**Amendments to the Drawings:**

**REMARKS/ARGUMENTS**

FIG. 4

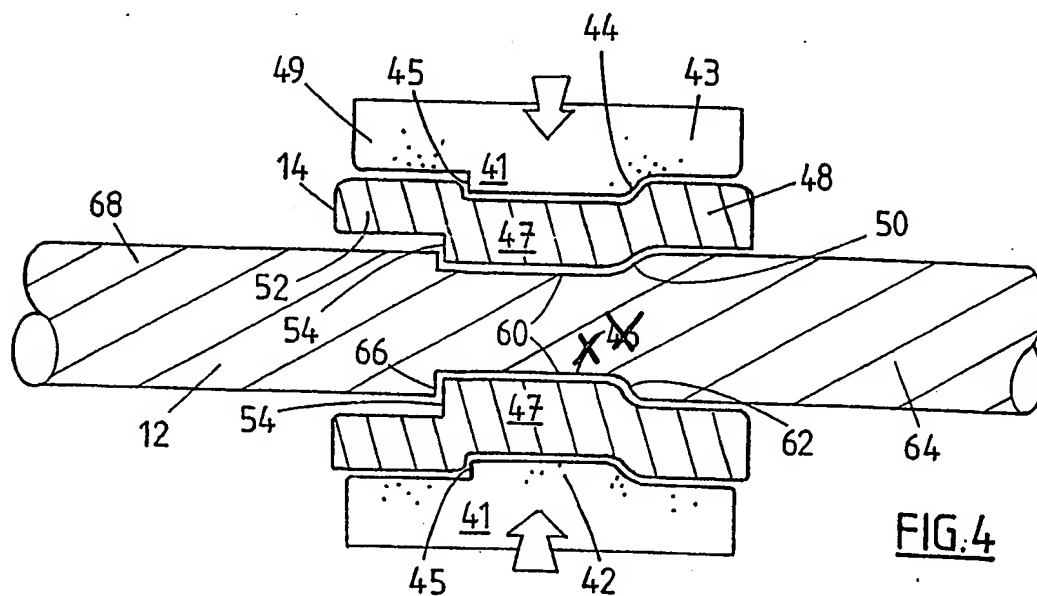
The attached sheet of drawings includes changes to Figs. 4 and 5. This sheet, which includes Figs. 3-5, replaces the original sheet including Figs. 3-5. In Figures 4 and 5 reference numeral 46 has been deleted.

Applicant submits herewith Replacement sheets of drawings wherein the reference numeral 46 has been deleted from Figures 4 and 5. It is respectfully submitted that the new sheet of drawings comply with all formal requirements.
